**SUBMITTAL TO THE BOARD OF SUPERVISORS  
COUNTY OF RIVERSIDE, STATE OF CALIFORNIA**

**SUBJECT:** TRANSPORTATION AND LAND MANAGEMENT AGENCY/TRANSPORTATION:  
Approve Addenda to the Plans and Specifications, Accept the Low Bid and Award the Contract for the Construction of Slurry Seal and Curb Ramp Accessibility Project for Fiscal Year 2021/22 at various locations; District 3. [\$4,505,051 Total Cost - Local Funds 100%] (Companion Item to MT No. 17976)

Refer to Plan Sheets for Slurry Seal and Curb Ramp Accessibility Project, For Fiscal Year 2021 – 2022, District 3. The following Plan sheets are revised and issued hereby as part of **Attachment “B”**.

SLURRY SEAL and  
CURB RAMP ACCESSIBILITY PROJECT  
FOR FISCAL YEAR 2021 - 2022  
DISTRICT 3, PROJECT No. D2-0008, D2-0013

01	TITLE
02-03	CURB RAMP TREATMENT INDEX
04-06	ROAD & TREATMENT INDEX
07	102
08	103B
09	107A
10	110-116B
11	114
12	122C
13	123A
14	1240-125C
15	1280
16	195B
17-20	ROAD INDEX
21-25	SIGNALIZED CURB RAMP
26-47	STRIPING PLANS

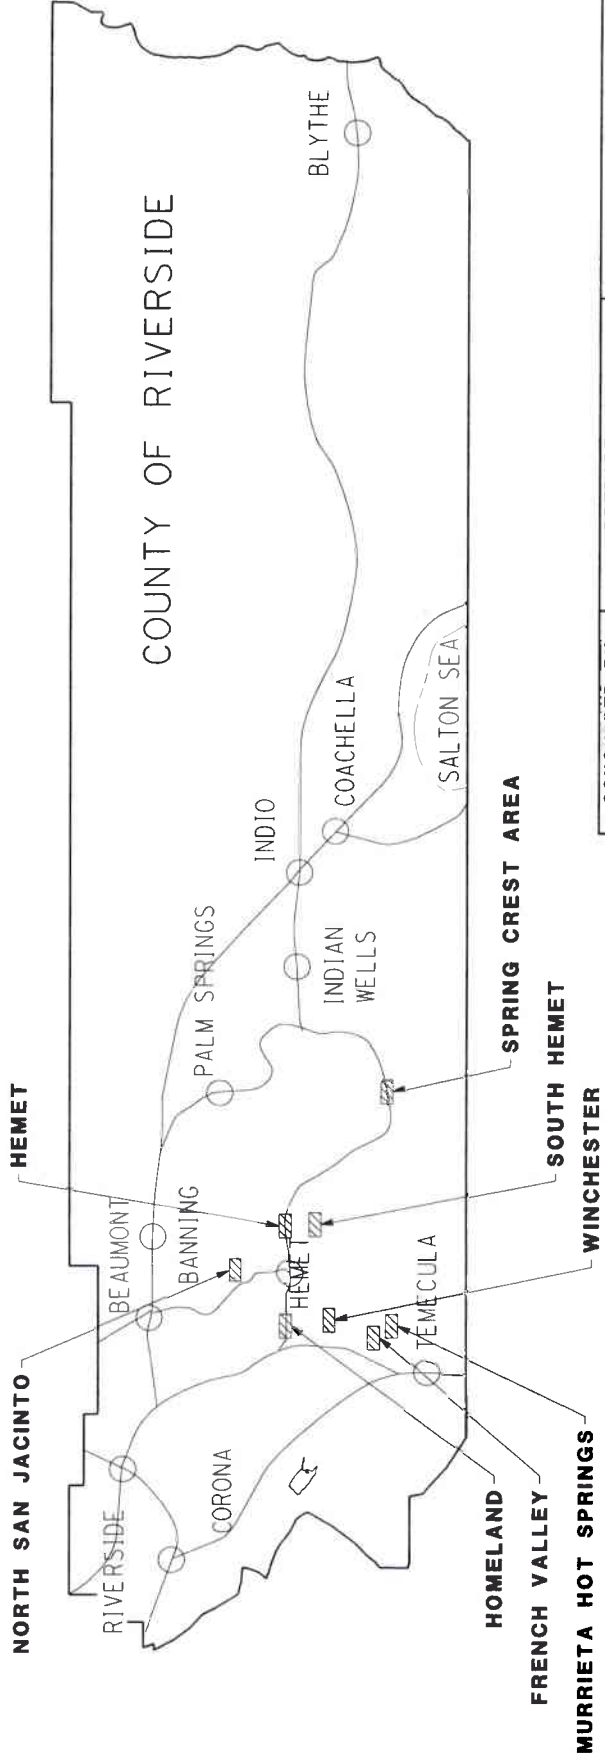
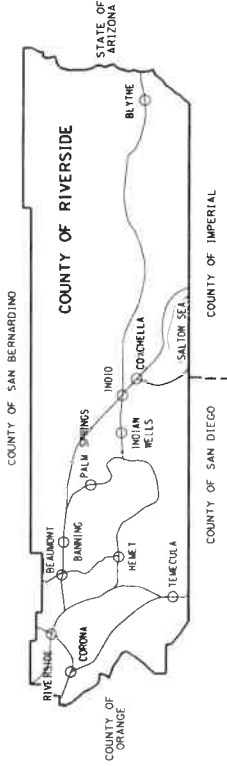
- Refer to General Note No. 1 on sheet 1 of 47.

Edition of the Standard Plans and Specifications was revised from 2015 to 2018.
